- A. Choke Shutter Interference - 1989-1/2 Mercury 35 Electric Start
- B. Parts Manual Volumes
- C. Decals Available - Mariner/Mercury 6/8/9.9/15 Models
- D. Rough Water Operation - XR4 and Magnum II Outboards

A. CHOKE SHUTTER INTERFERENCE - 1989-1/2 MERCURY 35 ELECTRIC START

Figure 1. Beginning 1989 1/2 Wire Routing

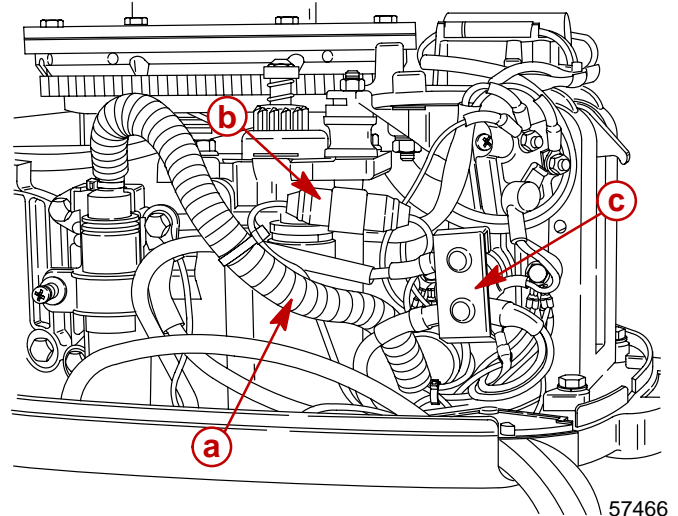
Electrical wire routed incorrectly may contact and restrict choke shutter movement on models listed. Restricted choke shutter movement may cause:

- **Hard Starting** by preventing full choke shutter closing
- **Rich Running** by preventing full choke shutter release

Beginning 1989 1/2 Models (Figure 1)—Reroute wire harness above fuse holder and solenoid as current models are routed (Figure 2) and secure to front cowl support rubber mount with sta-strap (P/N 54-90077). Install second sta-strap around front cowl support bracket and electrical wires to hold all wires forward and away from choke shutter area (Figure 3).

Figure 2. Current 1989 1/2 Wire Routing

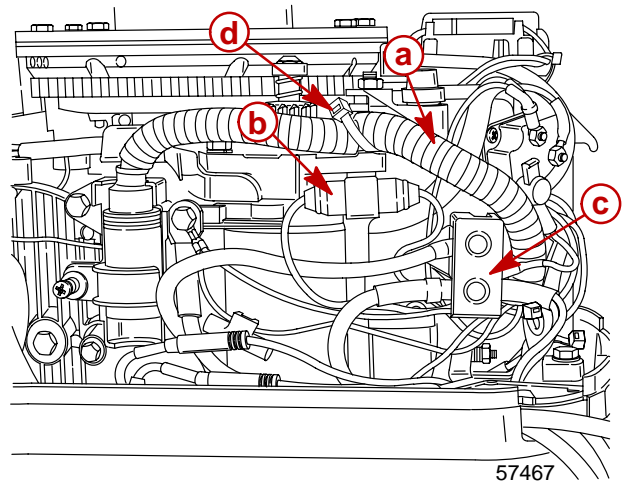
Current 1989 1/2 Models (Figure 2) — Install sta-strap (P/N 54-90077) around front cowl support bracket and electrical wires to hold all wires away from choke shutter area (Figure 3).
